OA2024/0020

**Application No: OA2024/0020**  
**Property: 41 Auburn Road Auburn**  
**Proposal: Other Authority Consent - Auburn Village mixed use development with infill affordable housing (SSD-69988710)**

Reference is made to the Department of Planning, Housing and Infrastructure referral received by Council on Thursday 12 December 2024 inviting Council's comments for the proposed development.

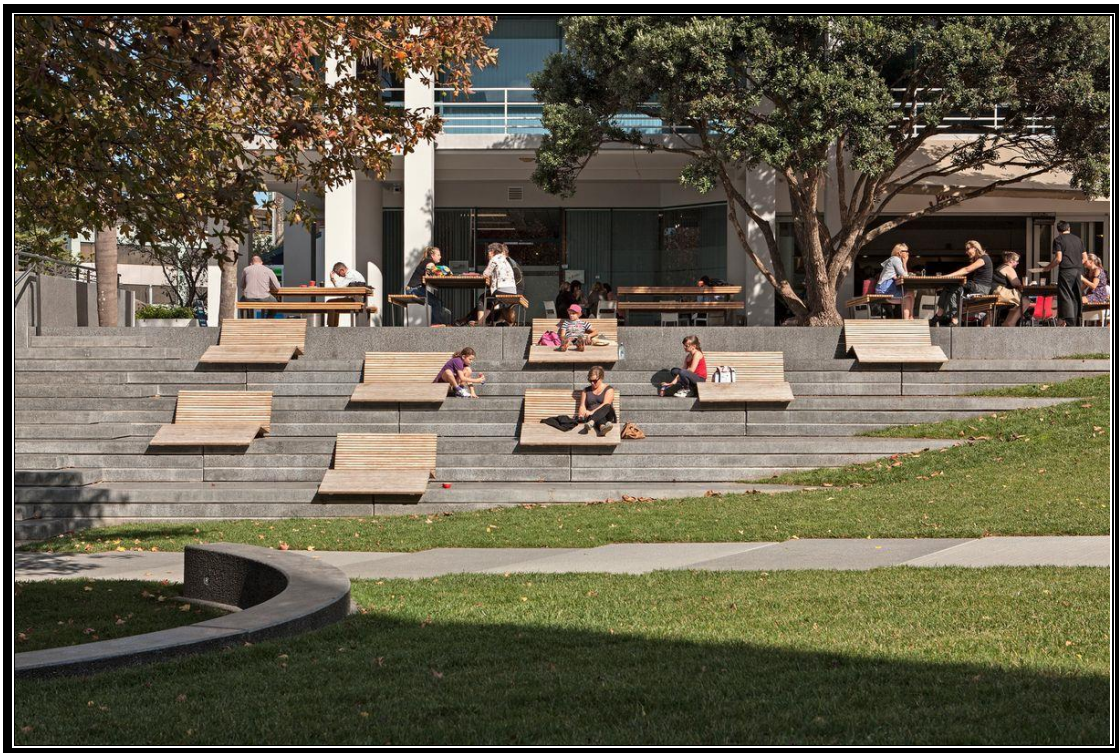
The development should address the following:

- Lack of seating and greenery.
- The development should improve on the area of open space at the intersection of Auburn Road and Queen Street that interacts visually and physically with the streetscape and includes public art and seating. This will support the urban principles for public open space that make the town centre connected, safe and accessible, culturally engaging, liveable and distinctive.
- Maximise the active street frontages along Auburn Road and Queen Street by keeping blank walls, vents etc to a minimum.
- Auburn Road - Provide new seating area, public art elements and new infill paving as per the Auburn Public Domain Plan. To protect existing tree planting.
- Provide new bins and seating along the streetscape.

A redesign of the open space facing the corner of Auburn Road and Queen Street is required. The proposed open space should be more open and inviting. The proposed planter boxes and retaining wall to address the level change is not desired. They create more obstacles both visually and physically for people to use the spaces and therefore, the useable area of the proposed open space is minimal.

A more creative solution is to be used to address the level change. This may be achieved by using long seating / stairs combination coupled with landscaping, as shown in the sample image below:

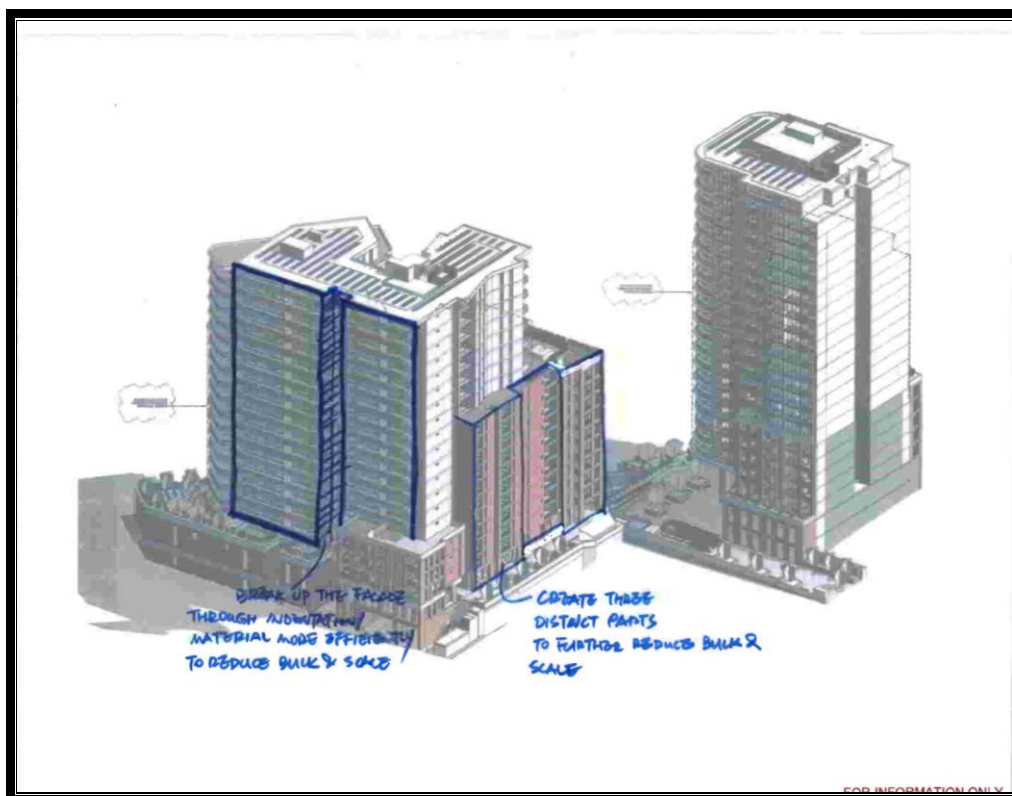
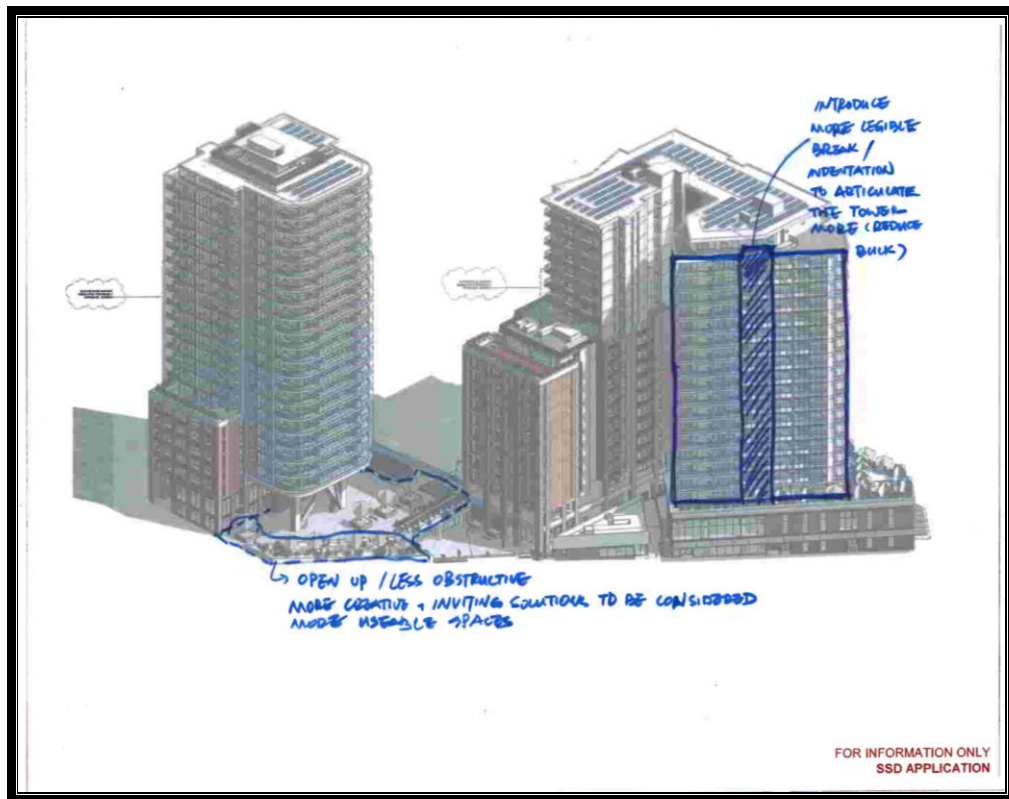
The design, bulk and scale of Tower B and C (The building closest to Auburn Central) is considered bulky. Consideration should be given to further breaking down the tower vertically to reduce its bulk and scale. This can easily be implemented through tools such as wider / more efficient indentations, material changes and groupings. Please refer to the mark ups provided below.
